PRODUCT BULLETIN

PB No. 118
Rev. 1

SUBJECT: New Lube Oil Header Design:
For Superior Inline Engines (**Upgrade**)

DRAWING NUMBER
P-012-378-SP-6

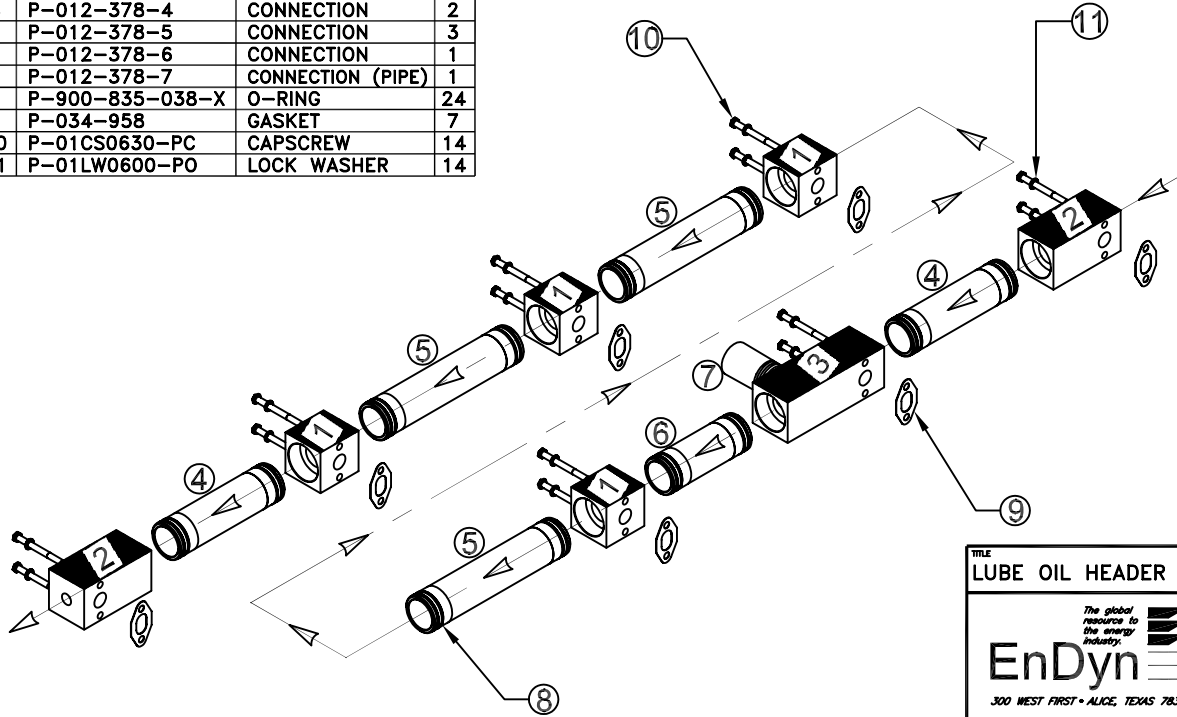
PROBLEMS: Existing fabricated Superior inline engines are equipped with copper & brass type lube oil headers. These headers are prone to develop leaks at the soldered joints, which creates downtime and costly repairs.

SOLUTIONS: In addition to our fabricated steel design (Ref. TB#111) EnDyn is pleased to announce an aluminum lube oil header design. This design is fully machined from a high grade aluminum alloy, complete with anodizing for protection from any corrosive environment. Additionally, upgraded viton o-rings (standard with our kit) provide superb sealing. A drawing of a typical header kit for an 8 & 6 cylinder engine is attached for review.
